**Southern California Edison**  
**Moorpark-Newbury A.13-10-021**

**DATA REQUEST SET A1310021 Moorpark-Newbury-ED-SCE-02**

SOUTHERN CALIFORNIA EDISON  
 MOORPARK-NEWBURY 66 kV SUBTRANSMISSION LINE PROJECT  
 VENTURA COUNTY, CALIFORNIA  
 PROPONENT'S ENVIRONMENTAL ASSESSMENT

Figure  
**3.5-1**

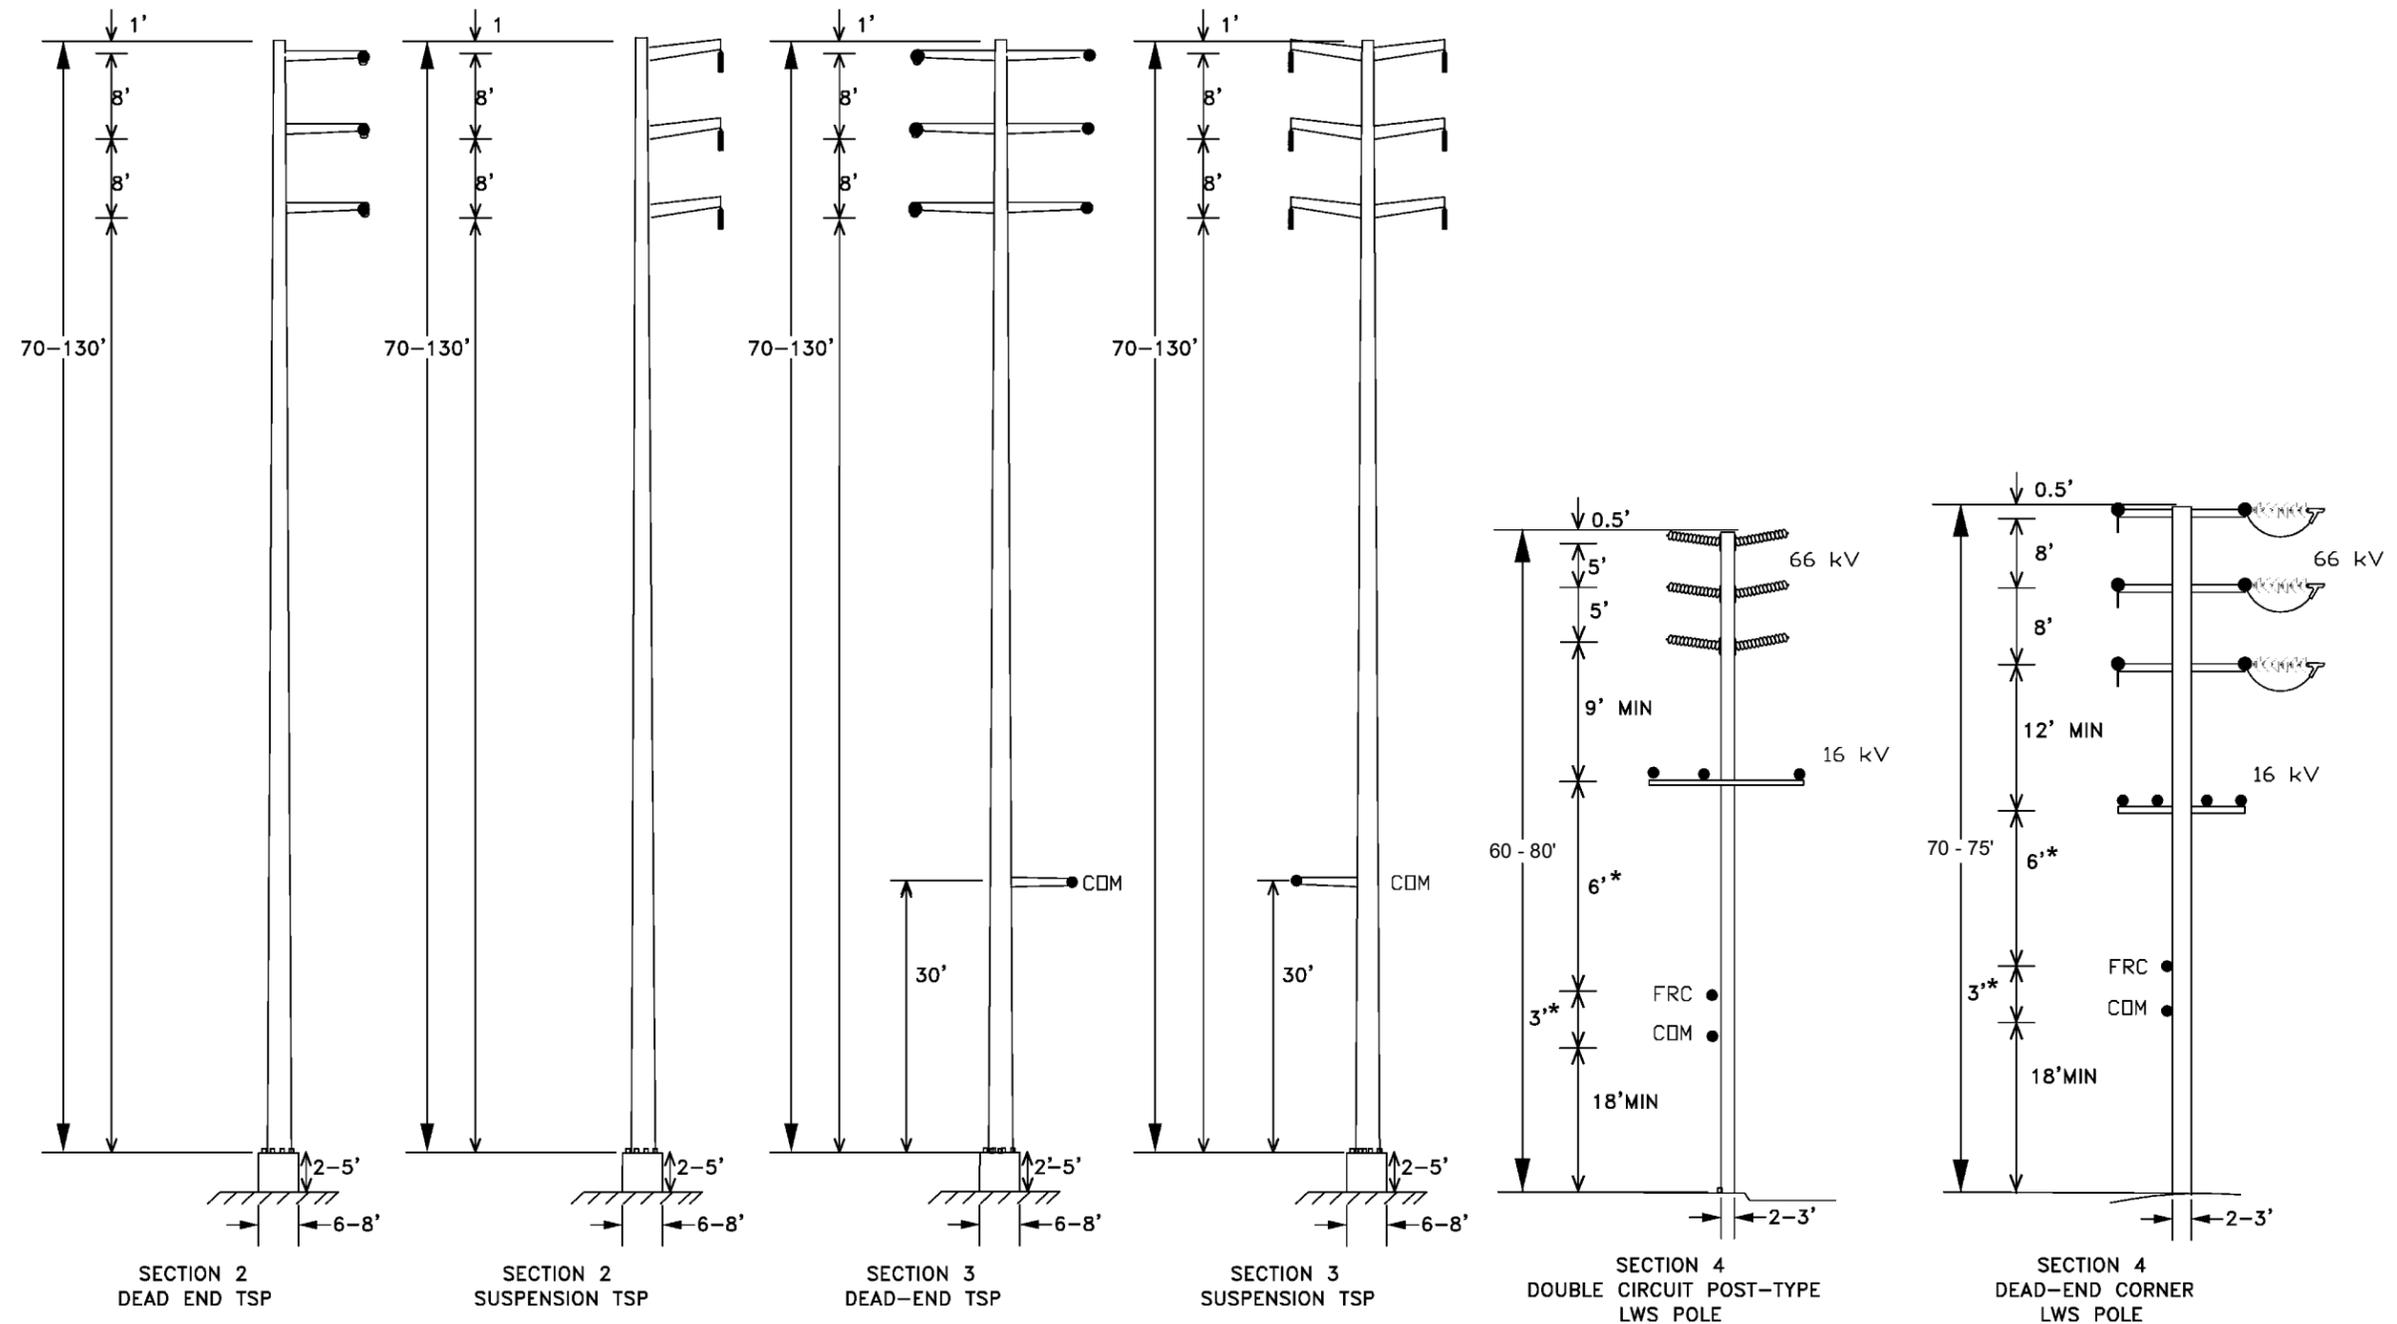
PEA Table 3.5-1 (page 3-29) and Section 3.5.2.1 (page 3-27) indicate that lightweight steel (LWS) poles would be 60 to 80 feet above ground. However, PEA Figure 3.5-1 shows LWS poles ranging in height from 60 to 75 feet above the ground surface. Please confirm the maximum LWS pole above ground height.

PEA Table 3.5-1 (page 3-29) and Section 3.5.2.2 (page 3-28) indicate that tubular steel poles (TSPs) would be 70 to 135 feet above ground. However, PEA Figure 3.5-1 shows TSPs ranging in height from 70 to 130 feet. Please confirm the maximum TSP height.

PEA Section 3.5.2.1.1 (page 3-28) states that conductor used to electrically ground the LWS poles “is typically located 1 to 2 feet above the telecommunications facilities and 4 to 6 feet below the distribution facilities.” However, PEA Figure 3.5-1 shows conductor used to electrically ground the LWS poles 3 feet above the telecommunications facilities, and a minimum of 6 feet below the distribution facilities. Please clarify which numbers are correct.

PEA Section 3.5.3.1 (page 3-29) states: "Subtransmission conductor installed on LWS poles is planned to be at least 50 feet above ground as measured at the pole..." However, Figure PEA 3.5.1 shows that the subtransmission conductor would be installed at least 36 or 39 feet above ground. Please clarify which numbers are correct.

The maximum above ground pole height for the LWS poles in Section 4 is approximately 80 feet. Please note, Figure 3.5-1 was incorrect in this regard. A revised Figure 3.5-1 is attached this response.

The maximum above ground pole height is 135 feet. The tallest pole is 130 feet and with an added 5 feet for the footing projection, the maximum above ground height would be 135 feet. A revised Figure 3.5-1 is included with SCE's response to Question 2.

A field visit confirmed that the installed FRC is between 3 and 6 feet above the communications level and it is at least 6 feet below the distribution facilities. However, it would be acceptable to install the FRC 1 to 2 feet above the telecom and 4 to 6 feet below the distribution facilities. The location of the FRC on the poles may depend on the space available on each particular pole, as well as the height of the pole and field conditions. A revised Figure 3.5-1 is included with SCE's response to Question 2 with clarification about potential FRC placement.

PEA Section 3.5.3.1 is correct. The 66 kV conductor would be at least 50 feet above ground as measured at the pole. The overall pole heights are shown in Figure 3.5-1, and the 66 kV conductor heights should be measured starting from the *top* elevation of the pole, going down. The separation between the conductor levels indicated for the sections below the 66 kV points of support can vary and the minimum G.O. 95 or typical SCE construction standard spacing is referenced. For the project configuration shown as "Section 4 Double Circuit Post-type LWS Pole" in Figure 3.5.1, the 66 kV lines are approximately 50 feet above ground. As noted in SCE's response to Question 2, the heights for the construction should be corrected to reference 60 feet to 80 feet above ground (the actual minimum pole height is 61 feet, SCE rounded this to 60 feet). For the project configuration shown as "Section 4 Dead-End Corner LWS Pole" the above ground heights are limited to 70-75 feet above ground height (this is within the 60-75 feet range shown in the figure). A revised Figure 3.5-1 is included with SCE's response to Question 2 reflecting this clarification.
